PWROG-15109-NP-A
Revision 0

PWR Pressure Vessel Nozzle Appendix G Evaluation

Cover Letter for the Final Safety Evaluation for the Topical Report PWROG-15109-NP, Revision 0, "PWR Pressure Vessel Nozzle Appendix G Evaluation," (EPID L-2018-TOP-0009), October 31, 2019.....	iv
Final Safety Evaluation by the Office of Nuclear Reactor Regulation for Pressurized Water Reactor Owners Group Topical Report PWROG-15109-NP, Revision 0, "PWR Pressure Vessel Nozzle Appendix G Evaluation," EPID L-2018-TOP-0009, October 2019.....	vii
PWR Owners Group Transmittal of PWROG-15109-NP, Revision 0, "PWR Pressure Vessel Nozzle Appendix G Evaluation," PA-MS-1091R4, OG-18-55, March 5, 2018	xxviii
PWROG-15109-NP, Revision 0, "PWR Pressure Vessel Nozzle Appendix G Evaluation," PA-MS-1091R4, February 2018	xxxii
PWR Owners Group Transmittal of the Response to Request for Additional Information, RAIs 1-6 Associated with PWROG-15109-NP, Revision 0, "PWR Pressure Vessel Nozzle Appendix G Evaluation," PA-MS-1091, OG-19-65, March 2019	A-2

Responses to the U.S. NRC Request for Additional Information on PWROG-15109-NP, "PWR Pressure Vessel Nozzle Appendix G Evaluation," RT-LTR-19-2, Rev. 0, March 2019	A-4

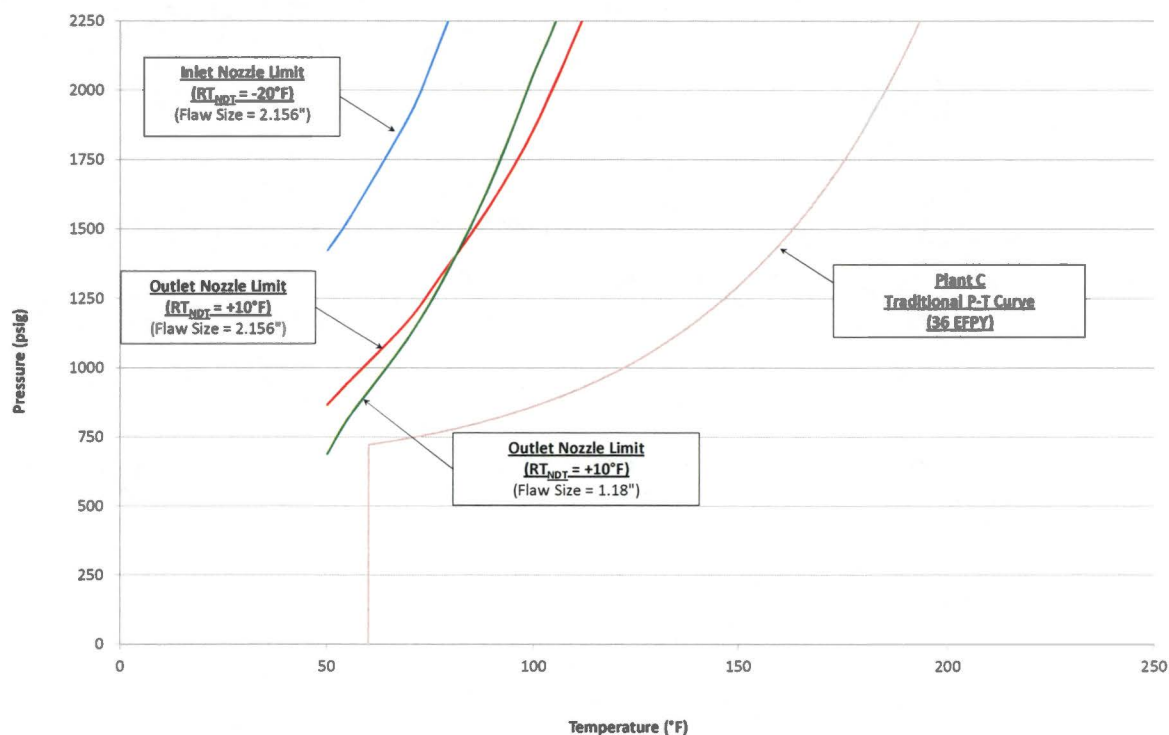
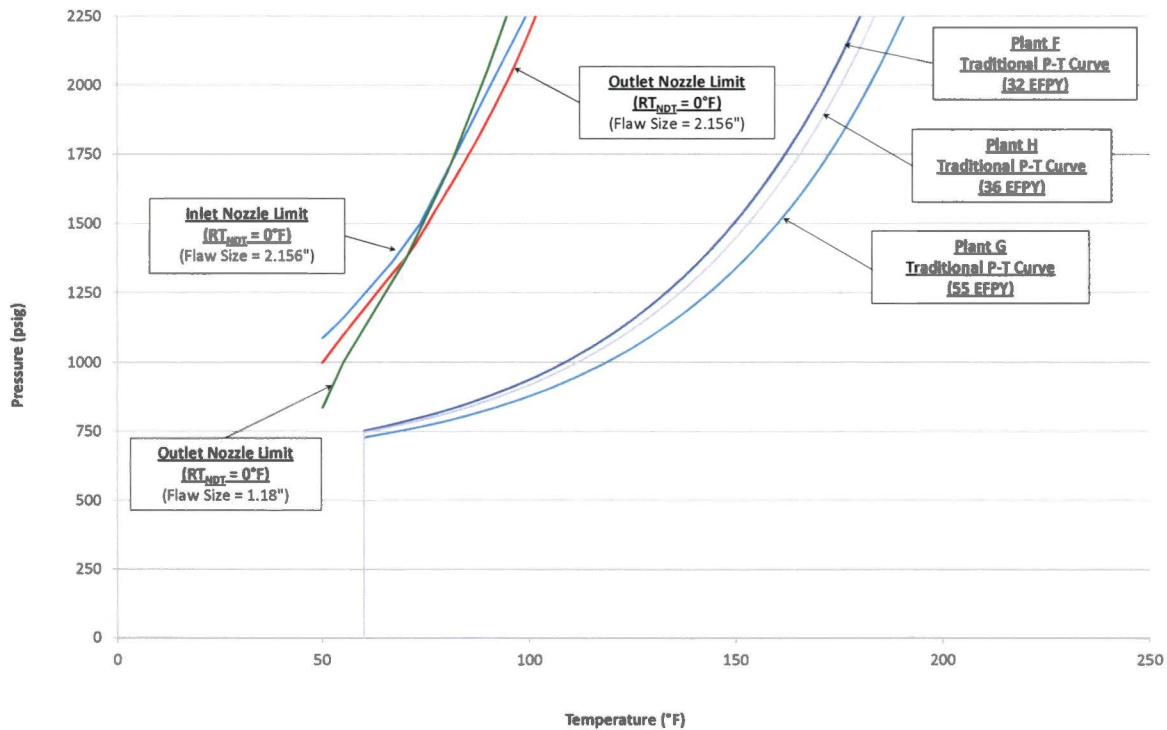
For Plant "C" through Plant "H," the staff noted the nozzle RT_{NDT} values were measured to the requirements of post-1973 ASME Subarticle NB-2300, and the uncertainty associated with an RT_{NDT} estimation method does not affect these RT_{NDT} values. The staff also noted that the PWROG used the FEM with postulated flaws in the TR to generate the nozzle P-T limit curves. The staff's review of the FEM with postulated flaws in the TR are documented in Sections 4.5 through 4.9 of this SE. Based on its review, the staff finds it acceptable that the PWROG used plant-specific nozzle RT_{NDT} values instead of the A-508 Class 2 generic RT_{TO} developed in this TR, along with the FEM with postulated flaws in the TR to generate the nozzle P-T limit curves. Thus, the staff finds the PWROG has adequately addressed that the NRC-approved P-T limit curves for Plant "C" through Plant "H" bound the nozzle P-T limit curve, as shown in Figures 5-10, 5-11, and 5-12 of the TR.

Figure 5-11 Westinghouse 4-Loop Bounding Nozzle P-T Limit Curves Compared to Flange-Exempt Plants D, E, J, and K NRC Approved Appendix G P-T Limit Curves

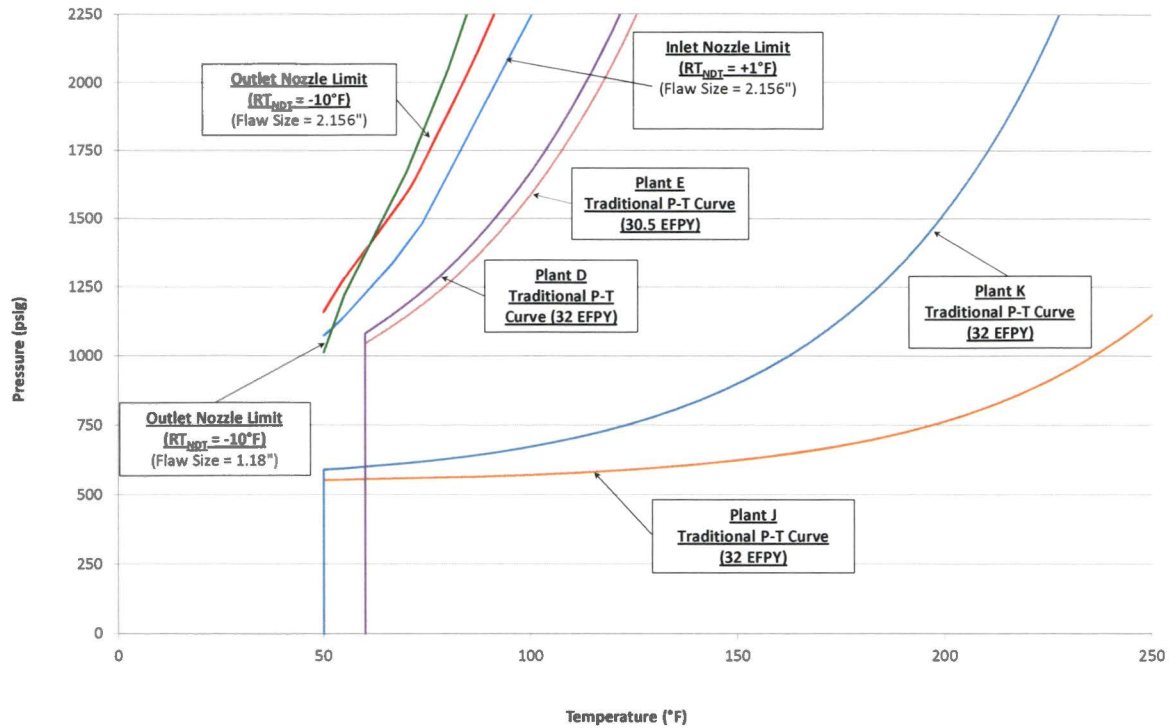
paragraph 1.1(3)(b). The staff noted that the methodology in BTP 5-3 paragraph 1.1(3)(b) was determined to be acceptable in closure memorandum dated April 2017 (ADAMS Accession No. ML16364A285). Based on the PWROG's confirmation regarding the source of the initial RT_{NDT} values for Plants "J" and "K," the staff finds the PWROG adequately addressed that the NRC-approved P-T limits curve for Plants "J" and "K" bounds their respective nozzle P-T limit curve, as shown in Figure 5-11 of the TR.

It is also noted that the Plants J and K nozzle P-T limit curves in PWROG-15109-NP Figure 5-11 are at a much higher pressure than the Plants J and K beltline P-T curve. Thus, there is large margin.

Figure 5-13 Westinghouse 4-Loop Bounding Nozzle P-T Limit Curves Compared to Flange-Exempt Plant I NRC Approved Appendix G P-T Limit Curves

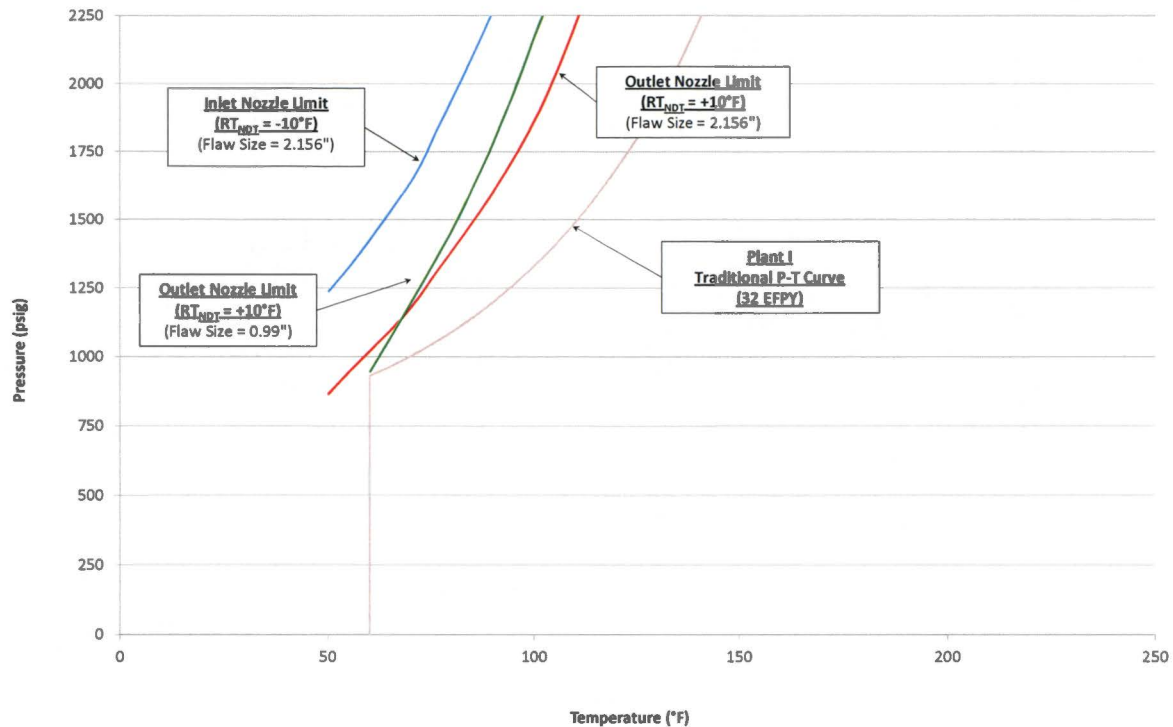
For Plant "I," the PWROG indicated in its supplement that the actual design dimension of the cladding (5/8 inch after machining) was utilized with the postulated 0.5-inch deep LAS flaw, which resulted in a flaw depth of 0.99 inch from the wetted surface. The SIFs for this 0.99-inch flaw in the FEM were developed using the same methodologies that were used for the other nozzle flaws in the TR. The staff's review of the FEM with postulated flaws in the TR are documented in Sections 4.5 through 4.9 of this SE. For Plant "I," the staff noted the nozzle RT_{NDT} values were measured to the requirements of post-1973 ASME Subarticle NB-2300, and the uncertainty associated with an RT_{NDT} estimation method does not affect these RT_{NDT} values. The staff finds it acceptable that the PWROG used plant-specific nozzle RT_{NDT} values instead of the A-508 Class 2 generic RT_{TO} developed in this TR, to generate the nozzle P-T limit curves. Based on the use of the plant-specific nozzle RT_{NDT} values and the PWROG's confirmation that the flaw size for Plant "I" is based on the plant-specific design dimension of the cladding thickness, the staff finds the PWROG adequately addressed that the NRC-approved P-T limits curve for Plant "I" bounds the nozzle P-T limit curve, as shown in Figure 5-13 of the TR.

- a) Describe and justify the P-T limit methodology used for the postulated flaw size of 0.99 inch in Figure 5-13 of the TR.*

Figure 5-14 Plant-Specific Large Flaw Nozzle P-T Limit Curves Compared to Plant A NRC Approved Appendix G P-T Limit Curves

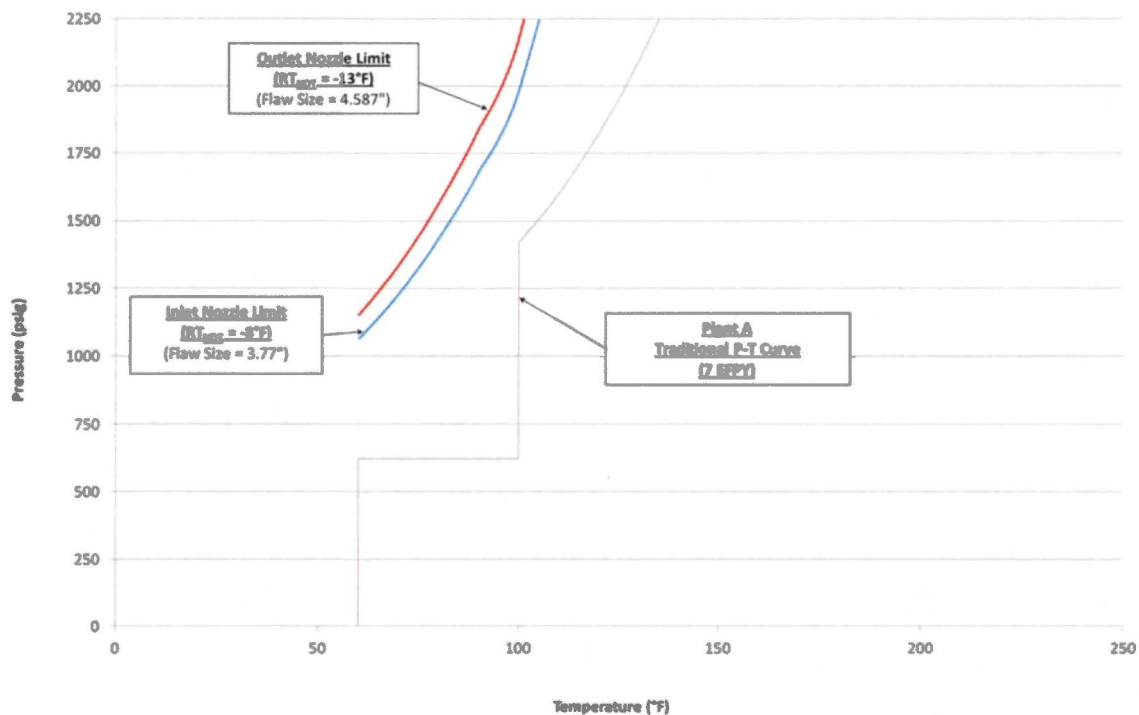
18191-NP, Appendix B, and verified that the licensee performed confirmatory P-T limit curve calculations of the RPV inlet and outlet nozzles. The staff noted that the Cu and Ni contents of the nozzles were based on plant-specific CMTRs and that the unirradiated RT_{NDT} values are based on drop-weight data, TL CVN test data and NUREG-0800 Branch Technical Position (BTP) 5-3, "Fracture Toughness Requirements," Positions 1.1(3)(a) and (b), with the more limiting unirradiated RT_{NDT} value being selected. The staff noted that the methodology in BTP 5-3 paragraph 1.1(3)(b) was determined to be acceptable in closure memorandum dated April 2017 (ADAMS Accession No. ML16364A285). The staff noted that the licensee performed these nozzle calculations solely to verify that the P-T limits for the RPV "traditional" beltline is bounding compared to any P-T limit curves for the RPV inlet and outlet nozzles. The staff verified that the licensee used the staff-developed methodology in ORNL/TM-2010/246 to generate the P-T limits of the nozzles. Based on its review of the pertinent information in WCAP-18191-NP, for the purposes of this TR, the staff finds the PWROG adequately addressed that the NRC-approved P-T limit curve for Plant "A" bounds the nozzle P-T limit curves, as shown in Figure 5-14 of the TR.

The relevant information for Plant A was submitted to the NRC in WCAP-18191-NP [19]. This WCAP contains a calculation of nozzle P-T limit curves using the standard 1/4T nozzle corner flaw and the standard ORNL/TM-2010/246 [20] method as presented in WCAP-18191-NP, Appendix B. WCAP-18191-NP also contains details of the determination of the initial RT_{NDT} values for the nozzle forgings. The nozzle P-T limit curves in WCAP-18191-NP correspond to end-of-license, but are conservatively applicable to 7 effective full-power years (EFPY), as in PWROG-15109-NP Figure 5-14, as well.

It is noted that the Plant A nozzle P-T limit curves were calculated using a very large 1/4T nozzle corner flaw and still show significant margin (PWROG-15109-NP Figure 5-14).

Figure 5-15 CE System-80 Nozzle P-T Limit Curves Compared to U.S. CE and B&W Design NRC Approved Appendix G P-T Limit Curves

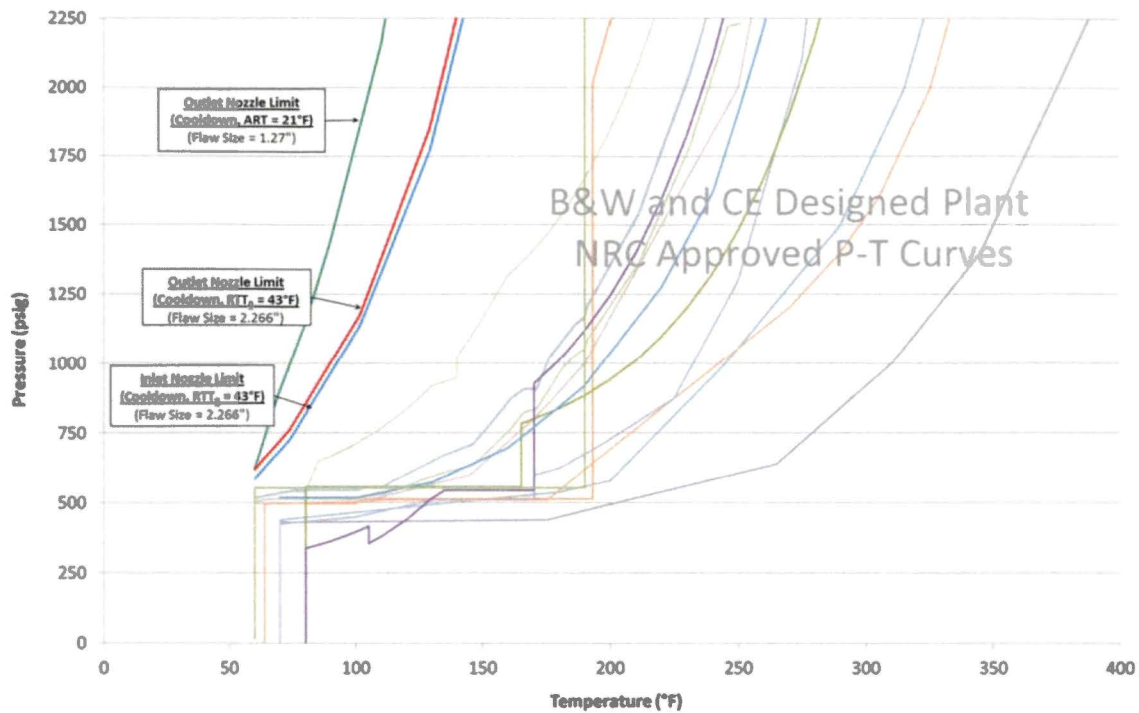
The staff reviewed Figure 5-15 of the TR, which provided a comparison of the bounding nozzle P-T limit curves compared to NRC-approved P-T limit curves for CE and B&W PWRs. Based on this comparison, the staff finds the PWROG adequately addressed that the NRC-approved P-T limit curves for CE and B&W PWRs bounds the generic nozzle P-T limit curves developed in this TR, as shown in Figure 5-9 of the TR. The staff reviewed Figure 5-9 of the TR, which provided a comparison of the Westinghouse bounding generic nozzle P-T limit curves compared to the NRC-approved P-T limit curves for Westinghouse PWRs, except for the eleven plant-specific cases which are further discussed below (i.e., Plants "A" through "K"). Based on this comparison, the staff finds the PWROG adequately addressed that the NRC-approved P-T limit curves for Westinghouse PWRs (except for Plants "A" through "K") bound the generic Westinghouse nozzle P-T limit curves developed in this TR, as shown in Figure 5-9 of the TR. The staff's review of Plants "A" through "K" identified in the TR is provided below.
